WCHS Track and Field: Change Order #04 Summary

| DATE: | 10/17/2024 | PR #: | PR 006 |
| TO: | Clay Ratliff – Trace Creek Construction | RE: | Woodford County Board of Education Versailles, Kentucky BG 19-353 RTA 1916 Phase 2 |

6 FIBER OPTIC ONE-LINE DIAGRAM
SCALE: NONE

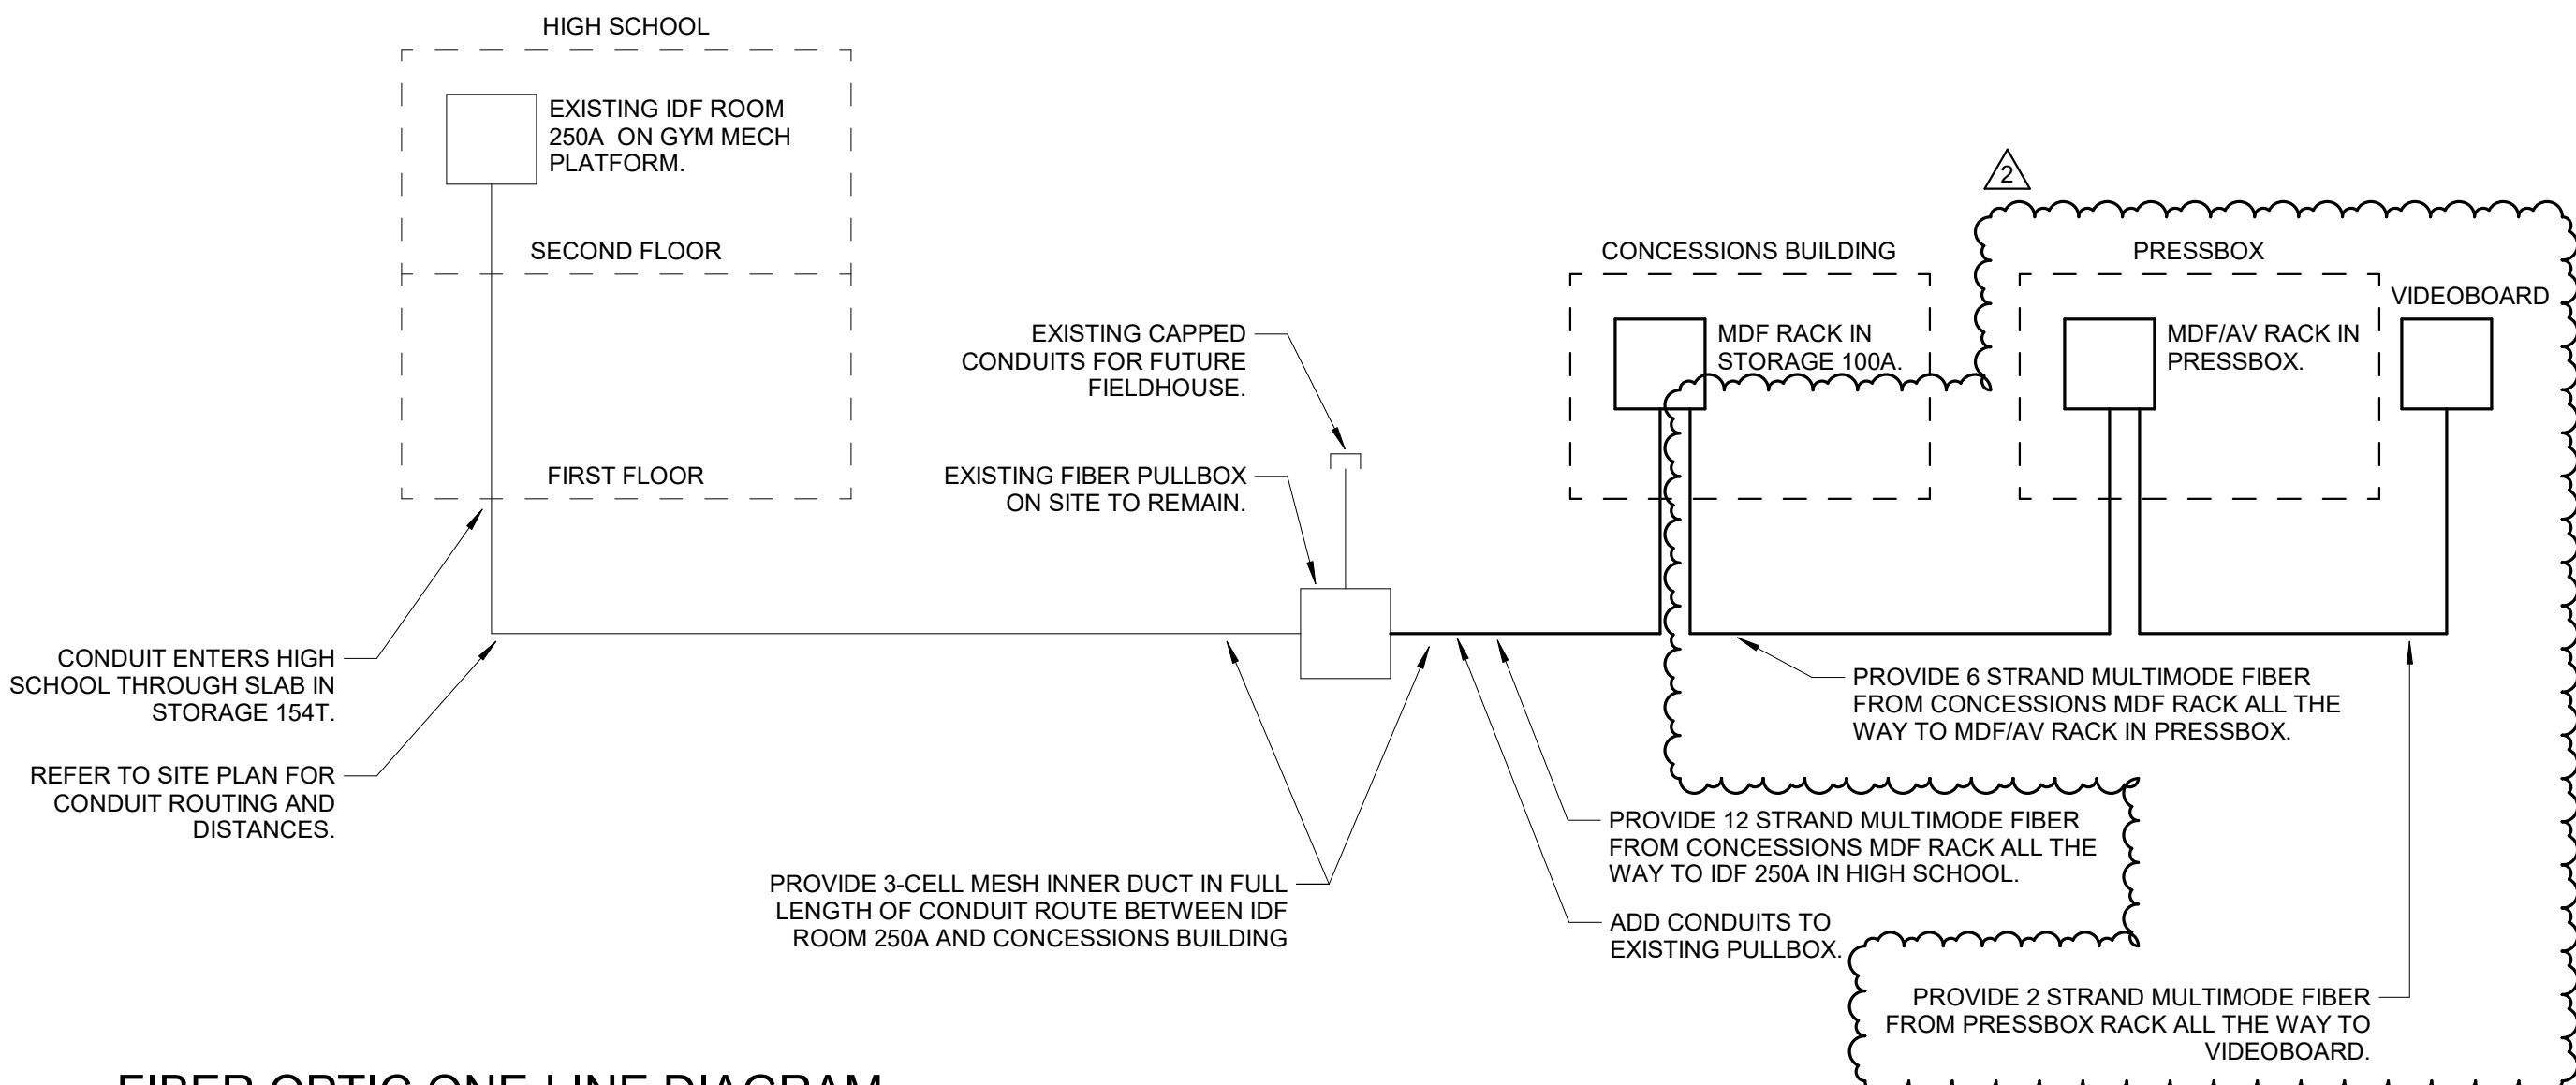
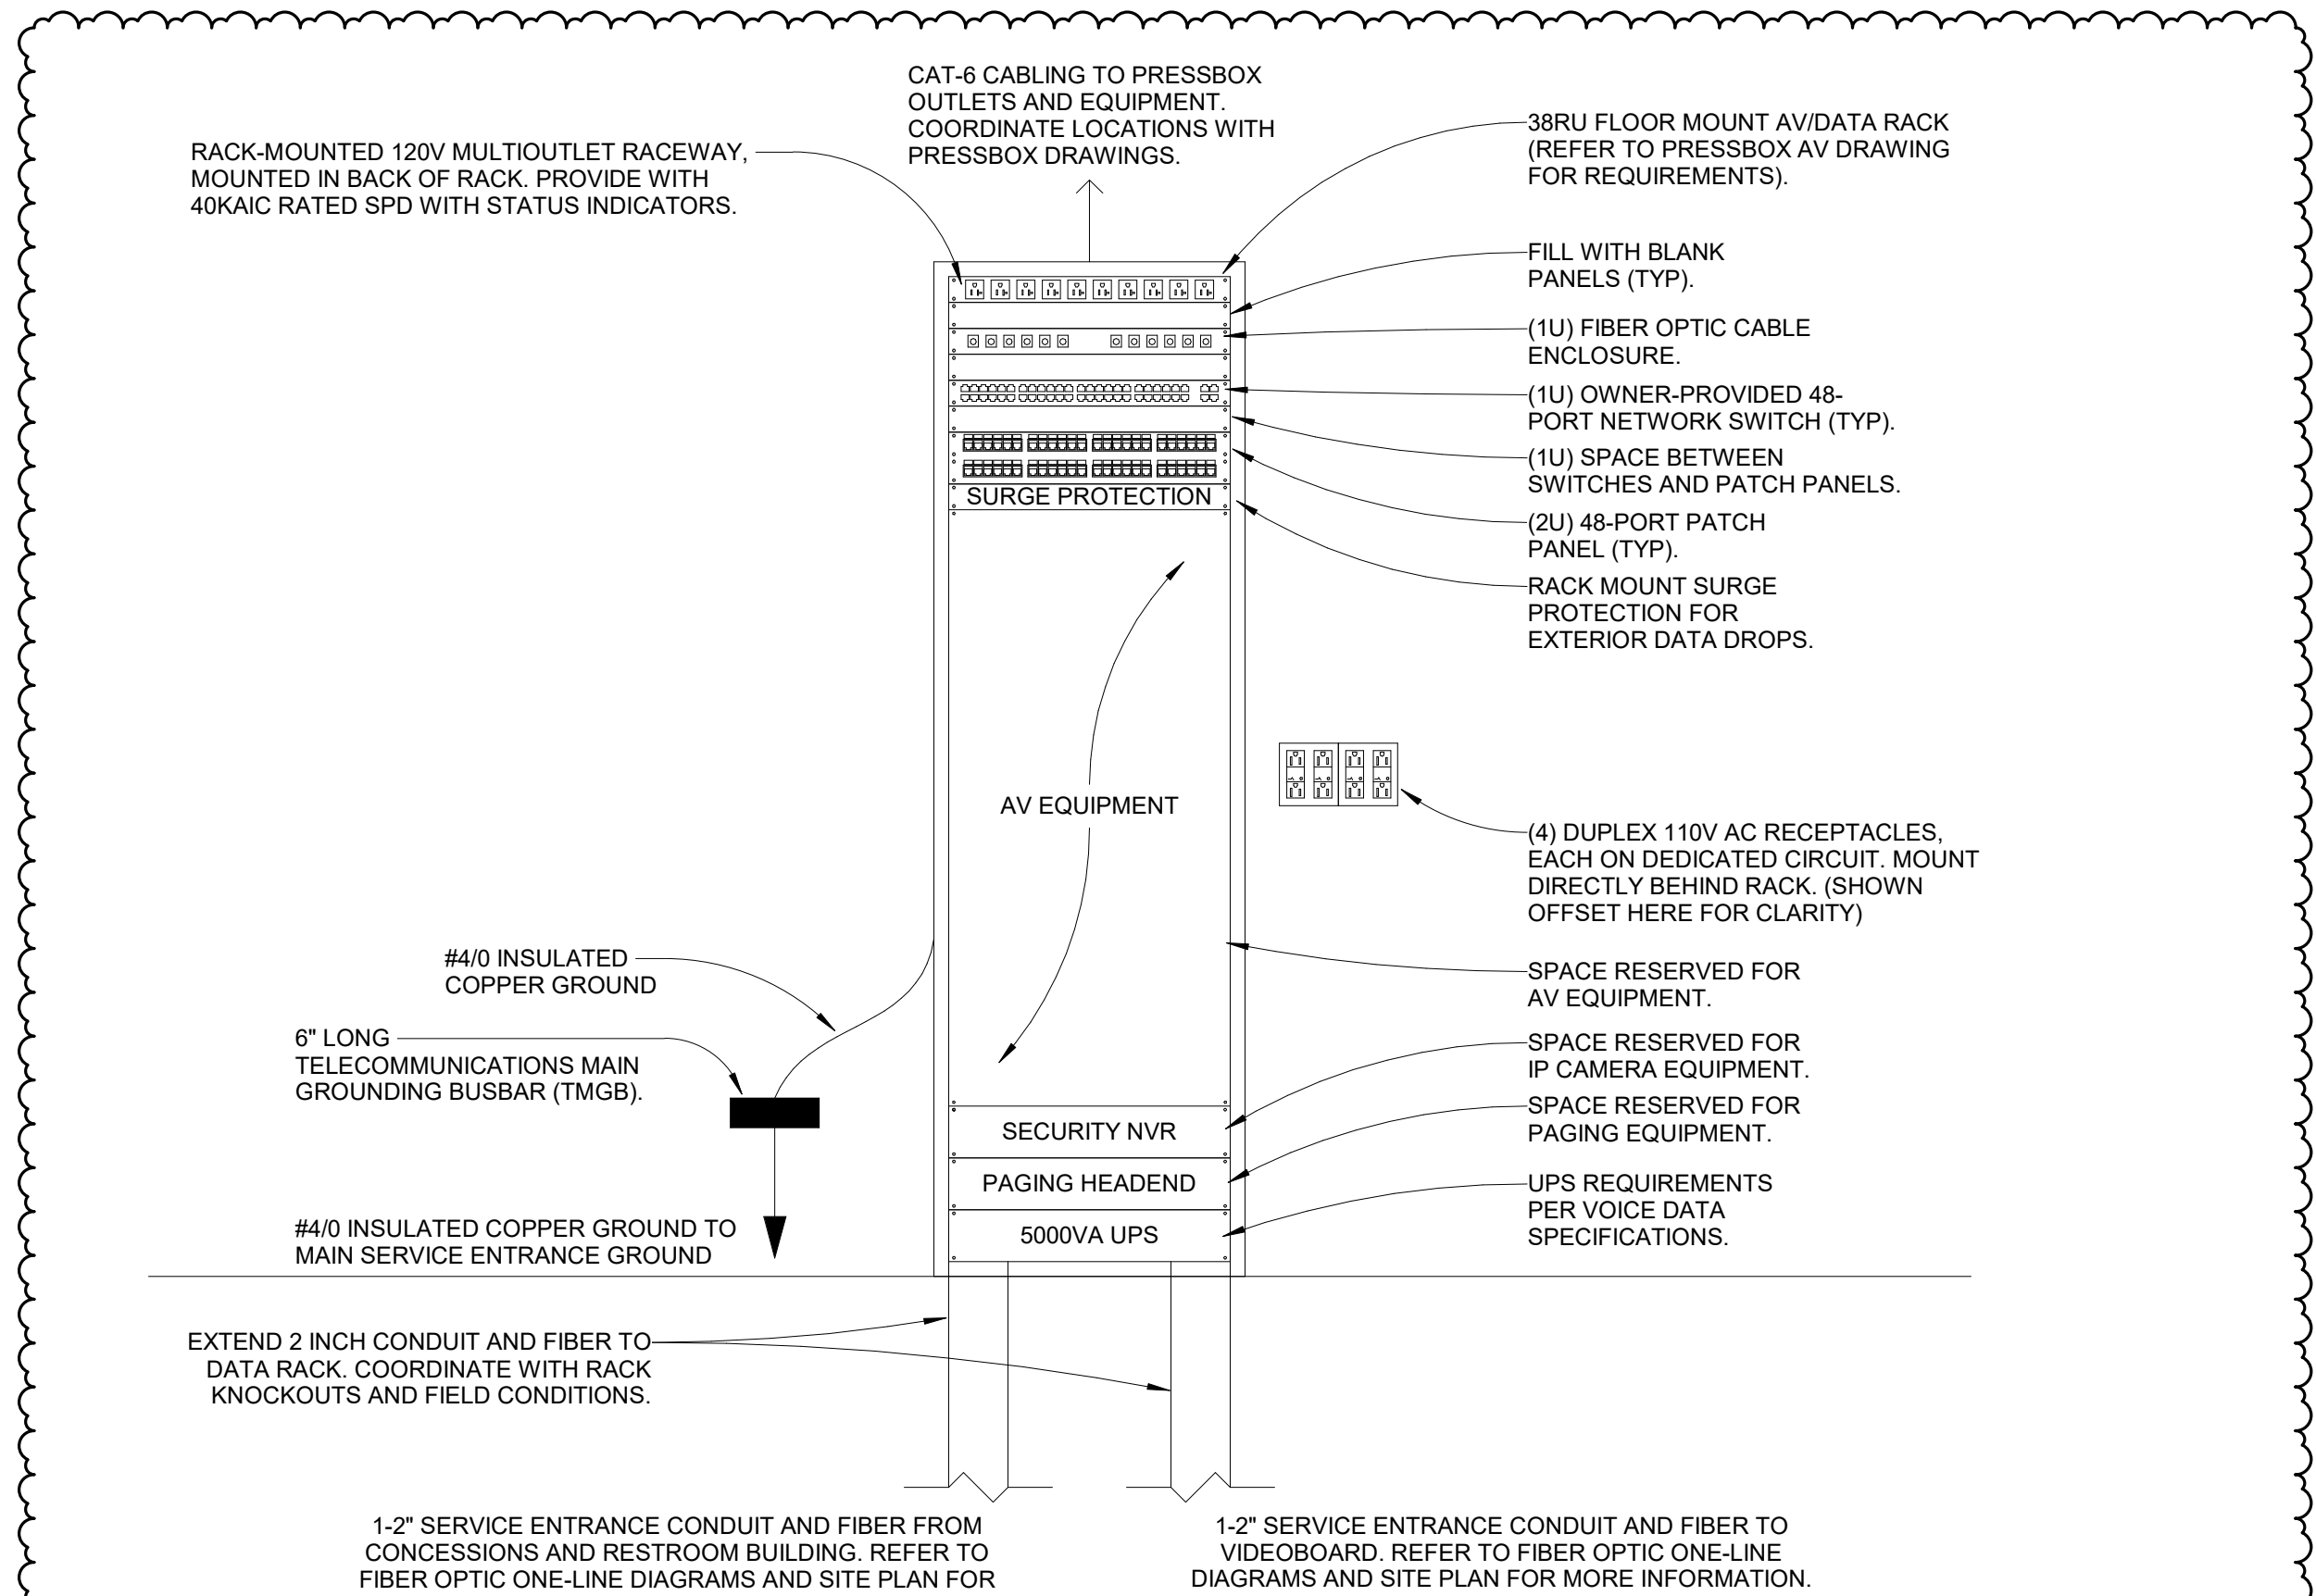
7. Add devices and equipment per E1.2 pressbox plans.
8. Add electrical equipment to support pressbox and videoboard per E2.0 one-line diagram.
9. Add pressbox communication riser and modify fiber one-line diagram to support pressbox and videoboard.
10. Provide a separate price to perform the following work: Upgrade athletic field lighting system to be 50FC.
